MINERALS PROGRAM INSPECTION REPORT PHONE: (303) 866-3567

MINE NAME:		MINE/PROSPECTING ID#:	MINERAL:	COUNTY:
Brighton Mine		M-1977-436	Sand and gravel	Adams
INSPECTION TYPE:		WEATHER: Clear	INSP. DATE:	INSP. TIME:
Surety-Related Inspection			September 2, 2025	10:00
OPERATOR:		OPERATOR REPRESENTATIVE:	TYPE OF OPERATION:	
Holcim - WCR, Inc.		Wyatt Webster	112c - Construction Regular Operation	
REASON FOR INSPECTION:		BOND CALCULATION TYPE:	BOND AMOUNT:	
Partial Acreage Release AR2		None	\$150,000.00	
DATE OF COMPLAINT:		POST INSP. CONTACTS:	JOINT INSP. AGENCY:	
NA		None	None	
INSPECTOR(S):	INSPECTOR'S SIGNATURE:		SIGNATURE DATE:	
Nikie Gagnon			September 11, 2025	
	1' ' 11			
	Aikie Bagnon

This inspection was completed as part of an acreage release request (AR3), submitted in accordance with Rule 4.17, received by the Division on August 19, 2025. Nikie Gagnon with the Division of Reclamation, Mining and Safety (Division) conducted the inspection. Wyatt Webster, representing Holcim-WCR Inc. (Operator) along with Jason Helms and Elena Acker, representing the City of Thornton (City), accompanied the Division during the inspection.

Figure 1: Map of the 7.0 acre stockpile and access road to be released, and the north area remaining in the permit.

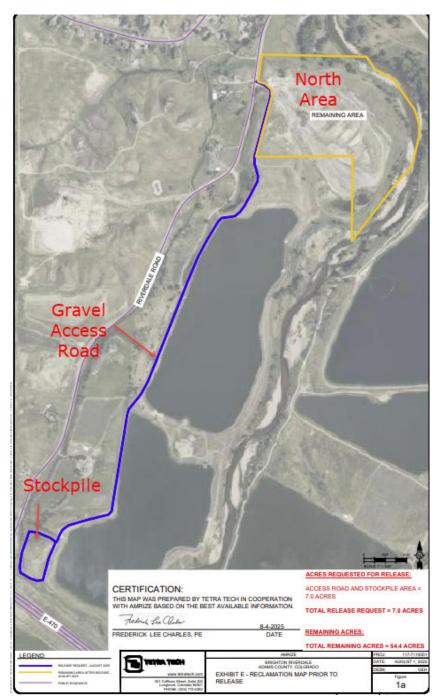
The operator submitted an acreage release for 7.0 acres which includes the access road and large stockpile adjacent to the South reservoir. The access road and the stockpile are on land owned by the City of Thornton. On July 17, 2025, the City sent a letter to the Division (enclosed), indicating that they do not object to the operator leaving the stockpile in the place for Thornton's future use. During this inspection the Division observed the stockpile in the southwest corner of the permit area. The stockpile is stable and no erosion rills or gullies were observed. Shrubs, primarily rabbitbrush and sage, were observed on the south and west sides along with native grasses. Annual weeds interspersed with grasses cover the east and north sides. Vegetation on the slopes is sufficient to control erosion and meets the requirements of Rule 3.1.6(3).

Based on the observations during this inspection, the Division will approve the request for a release of the 7.0 acres encompassing the stockpile and the gravel access road on the City property. A notice of the decision will be sent under separate cover.
